CHANGE ORDER

PROJECT: Maven Outdoor Equipment Company
Headquarters
1042 Pronghorn Drive
Lander, Wyoming

CHANGE ORDER NO. 8

Landscape Changes as shown in PR 23 and COP 23 for the add amount of \$4,817

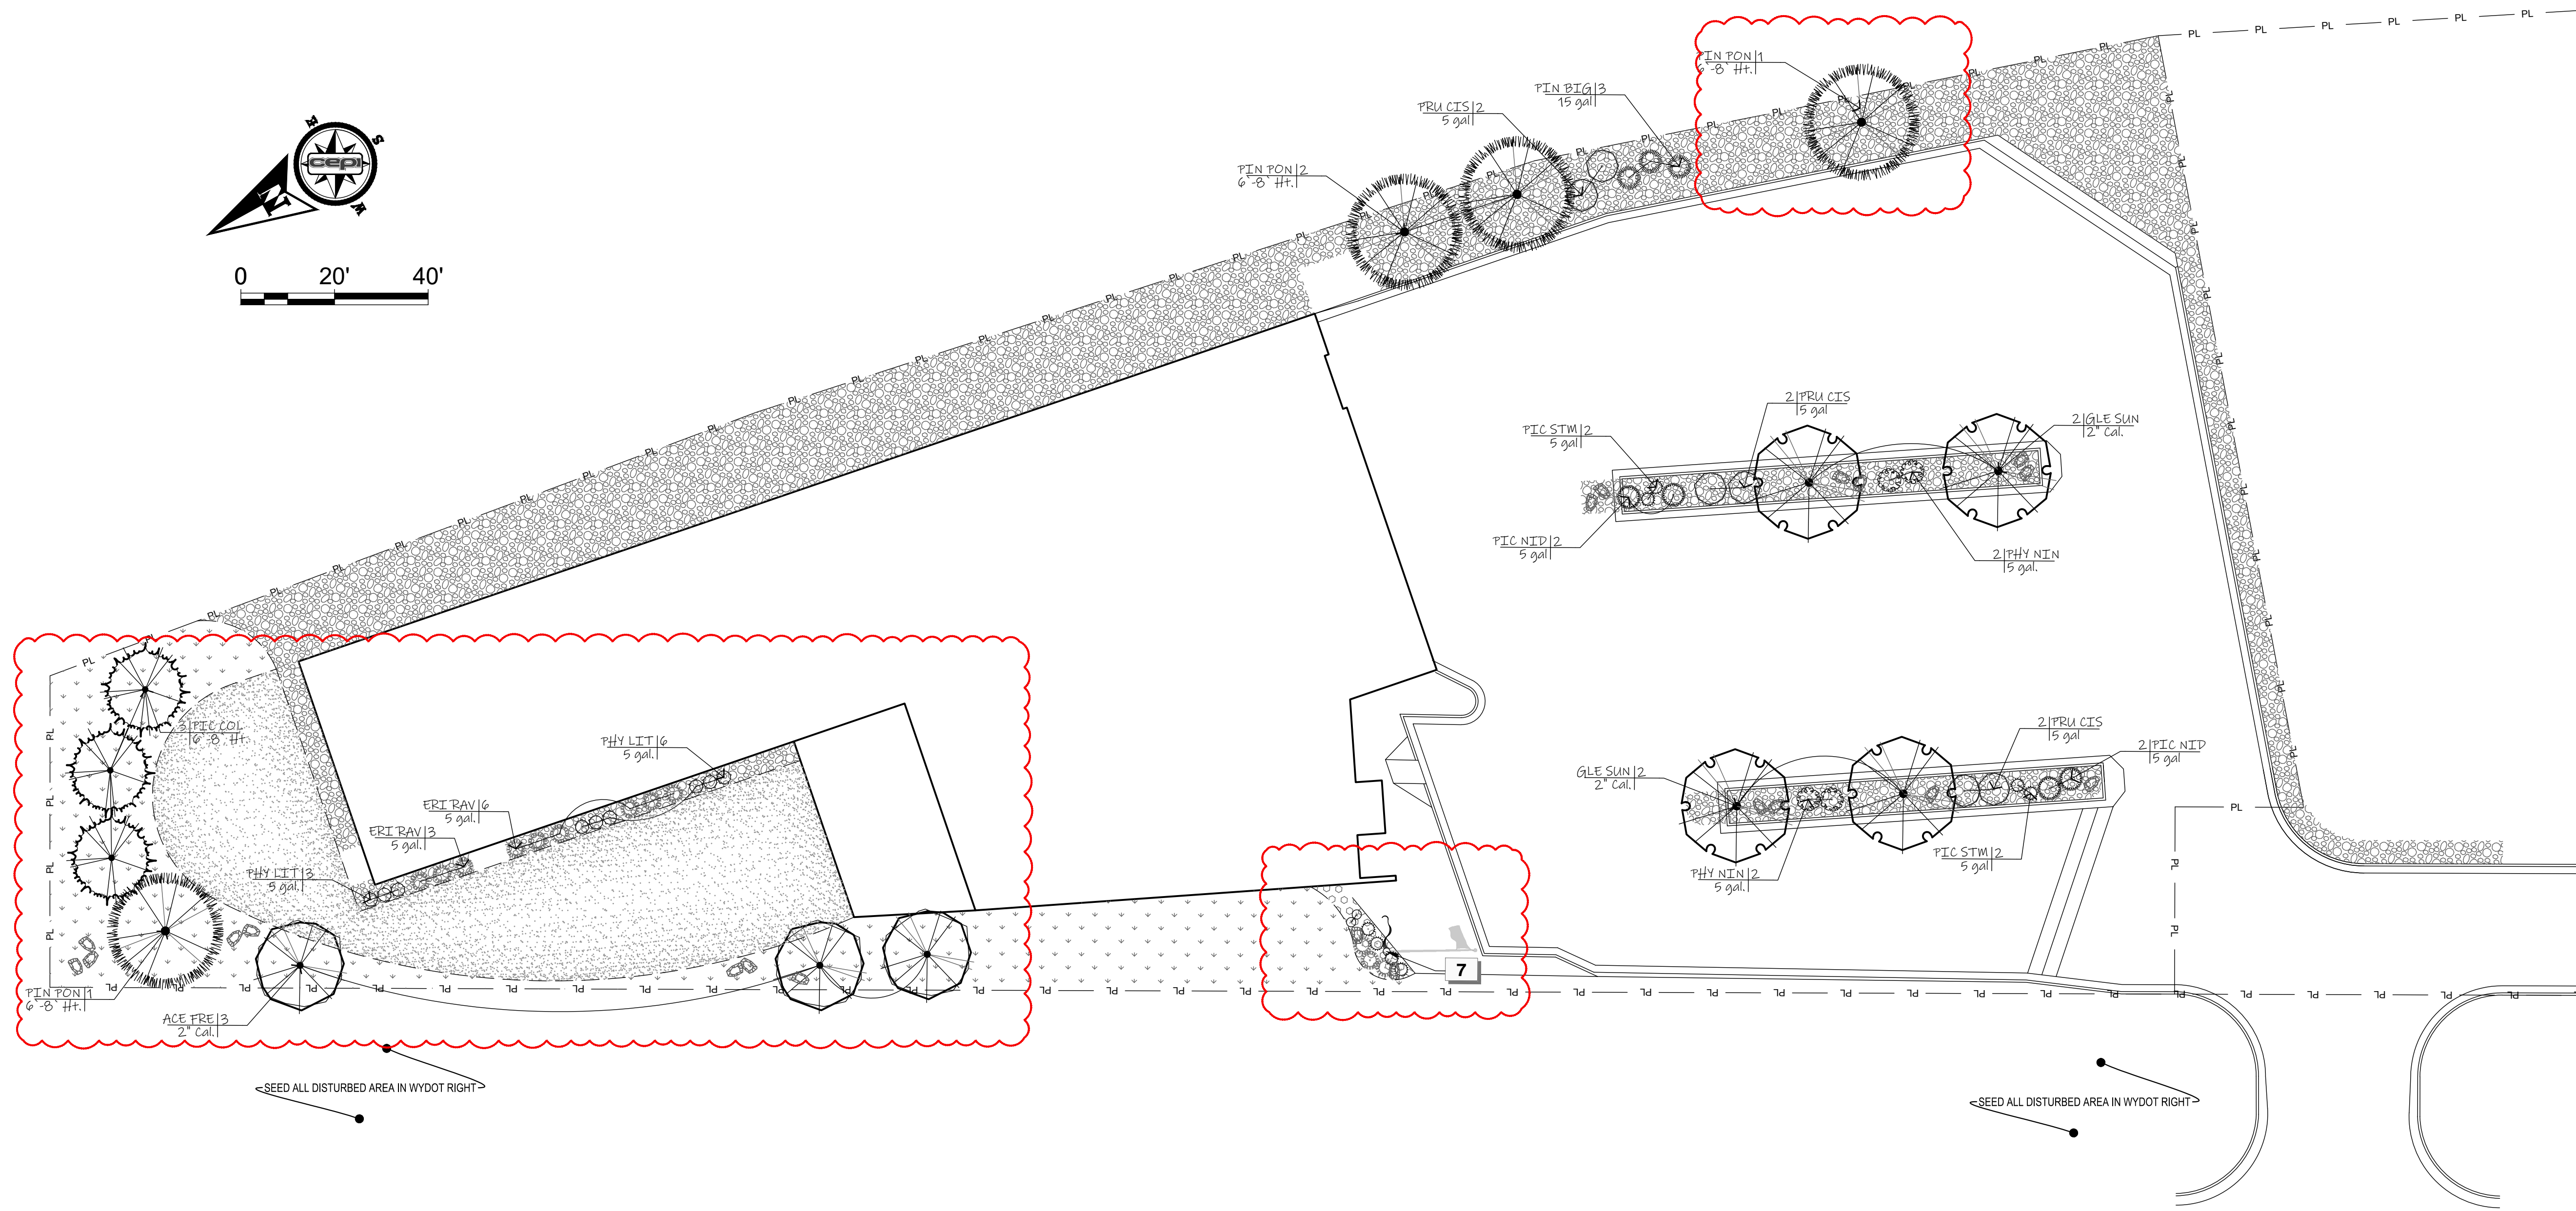
NOTES: This COP is the result of changes per PR 23 Landscape Changes. This proposal does not include costs for the following not illustrated in the PR:

1. Dirt Grades for extending out into the easement
2. Address what to do around the State survey point west of the parking lot
3. Demo of existing Trees
4. Irrigation into the easement

DESCRIPTION: Revise the landscape and irrigation plans as shown on the attached.

IRRIGATION PLAN
 SHEET
 I-1.0

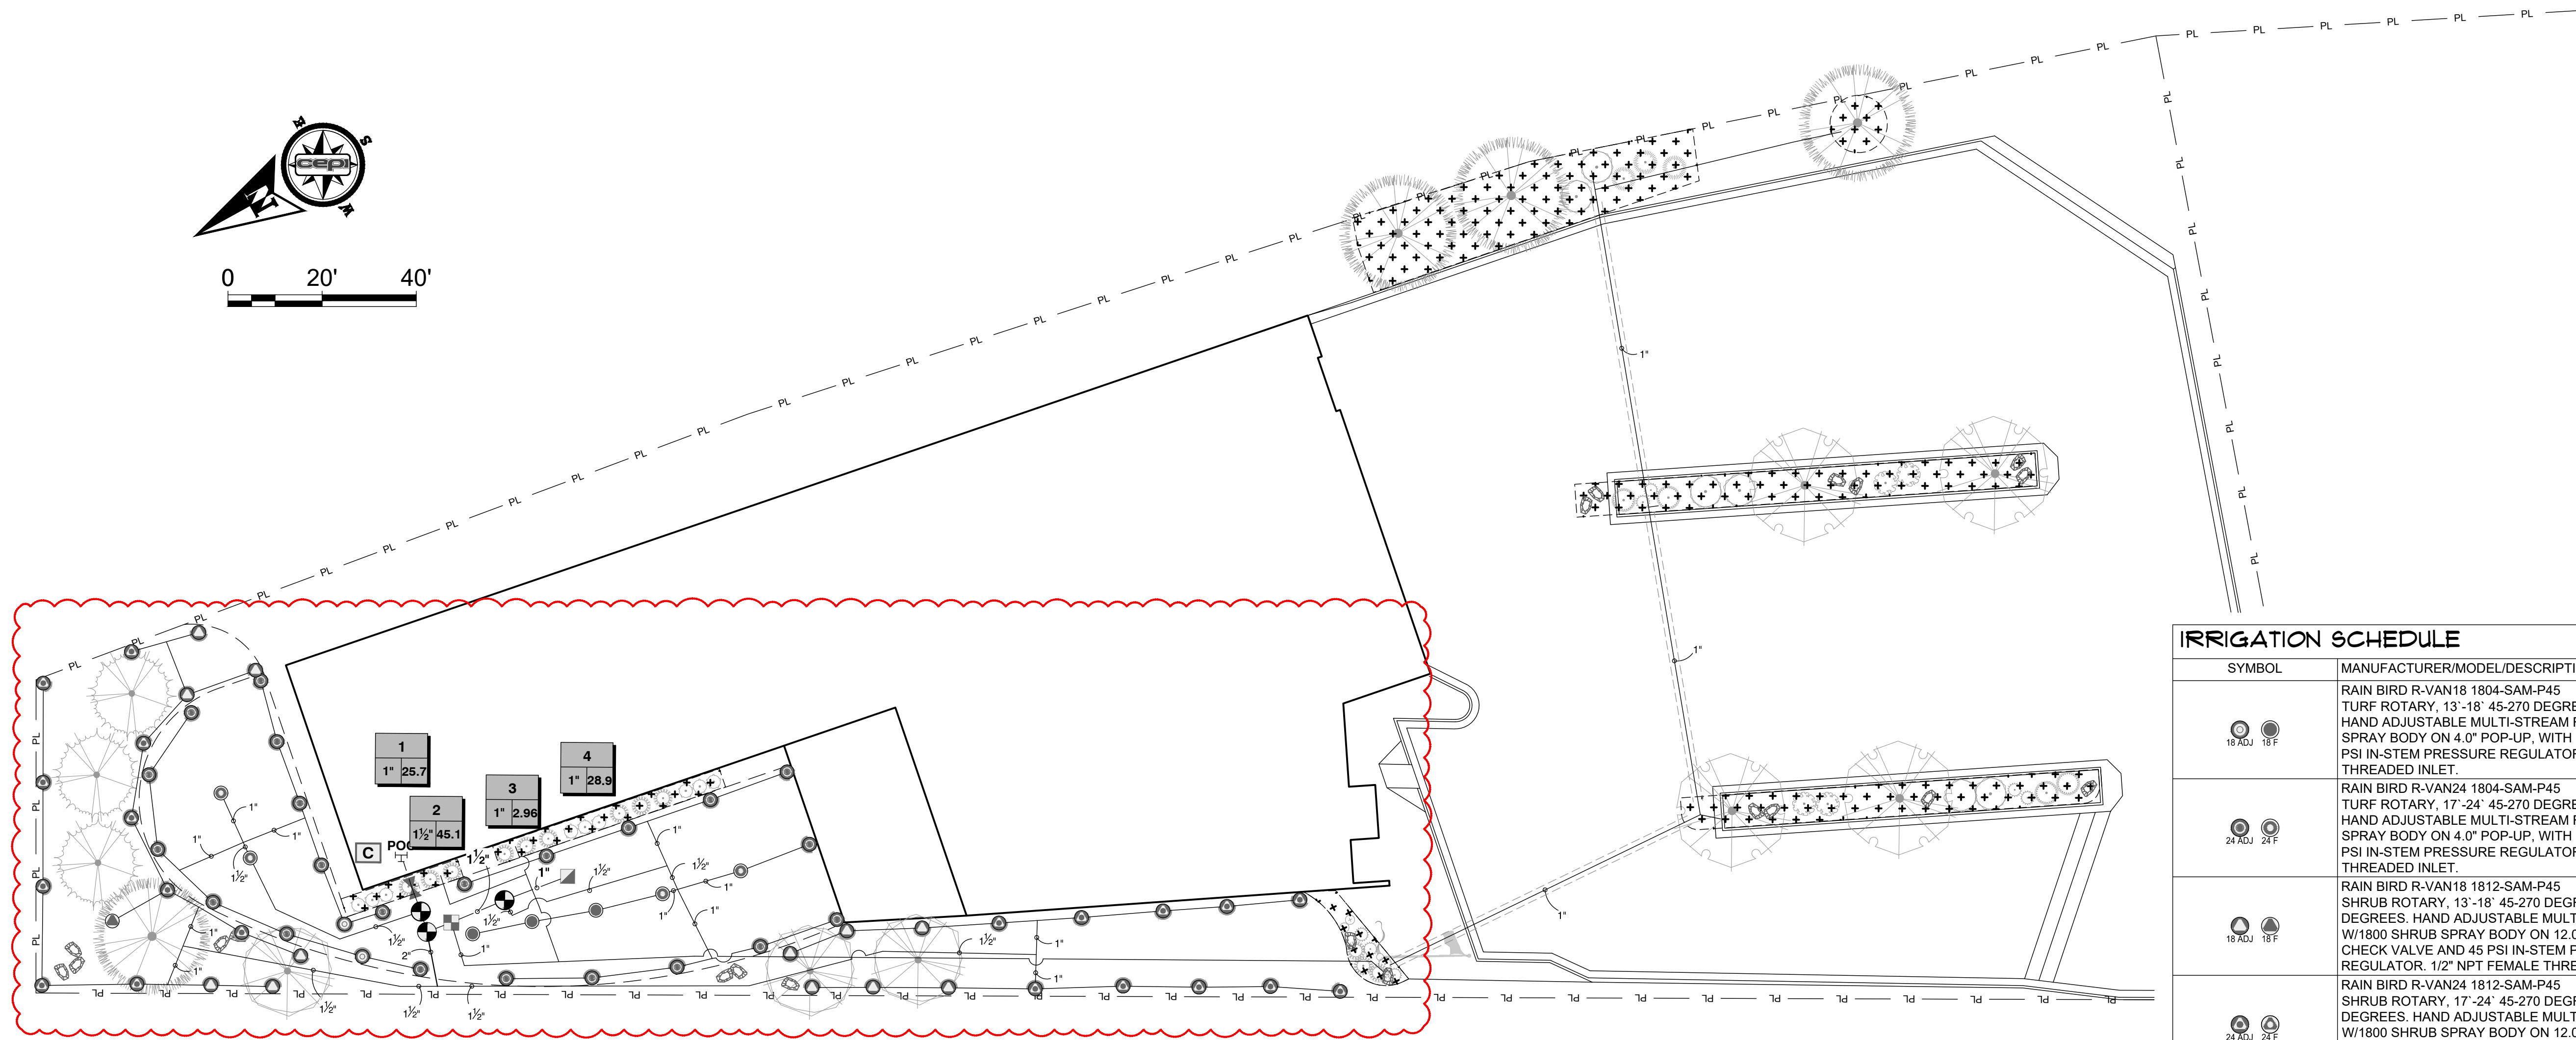
| NO. | DESCRIPTION |
|-----|-----------------------------|
| 1 | LANDSCAPE IRRIGATION CHANGE |
